Northern Interchange Shaft Construction Amendment

1. Introduction

The amendments completed to Table 3-1 in this revision (Rev 10) of the AFMP involve the following:

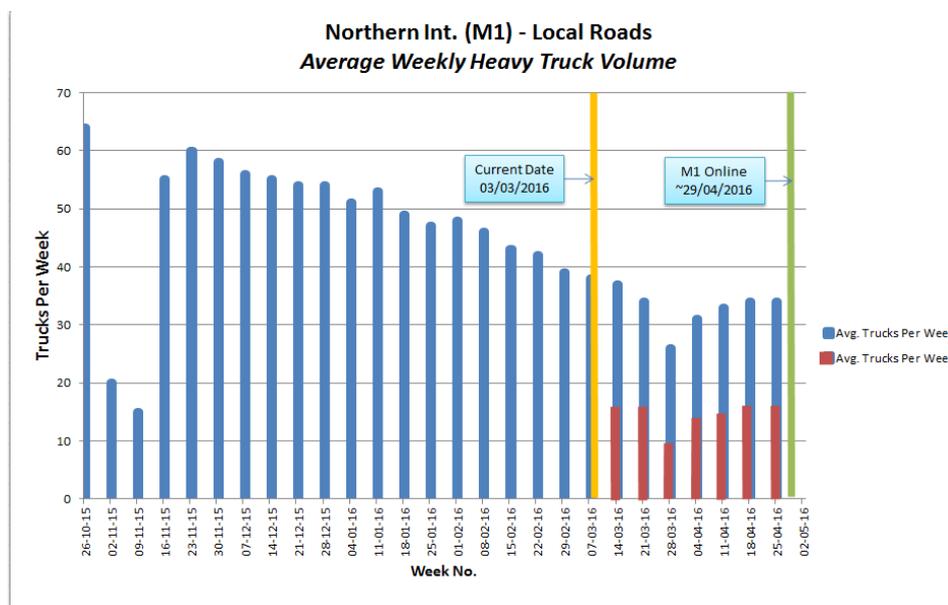
- The insertion of a new phase titled “**Early Operation Phase**” that involves the delivery of concrete and removal of spoil excavated from the shaft for a defined period using local roads until the M1 access is completed. It is noted that local roads that would be used are those already defined in the Traffic Management and Safety Plan for the site establishment phase. The likely frequencies of heavy vehicles during this time are outlined below.

- This approach is consistent with the information presented within the SPIR (Table 2-88 below) which indicates that shaft excavations would commence while the sites are being established (see below).

- The change proposed above will ensure that the limited use of some local roads (identified in the Traffic Management and Safety Plan - TMSP) by heavy vehicles to access the site is adequately covered by the AFMP approval.

- Heavy vehicle movements associated with the proposal will be consistent with the current levels of heavy vehicle movements associated with “establishment” phase of the Northern Interchange Compound (Please refer to extract from Set 1 of Appendix C of the TMSP at the end of this assessment). That is, there will be (on average) 15 - 18 trucks per week, delivering concrete or removing spoil. The graph below shows that the heavy vehicles associated with the site establishment phase (blue) is currently on a downward trend in line with the site establishment phase delivery requirements reducing over time. The proposal will see some of the downward trend being taken up by the inclusion of the heavy vehicles to support the shaft excavation works (red). Combined heavy movements associated with all activities occurring at the site would be well within the 60 heavy vehicle
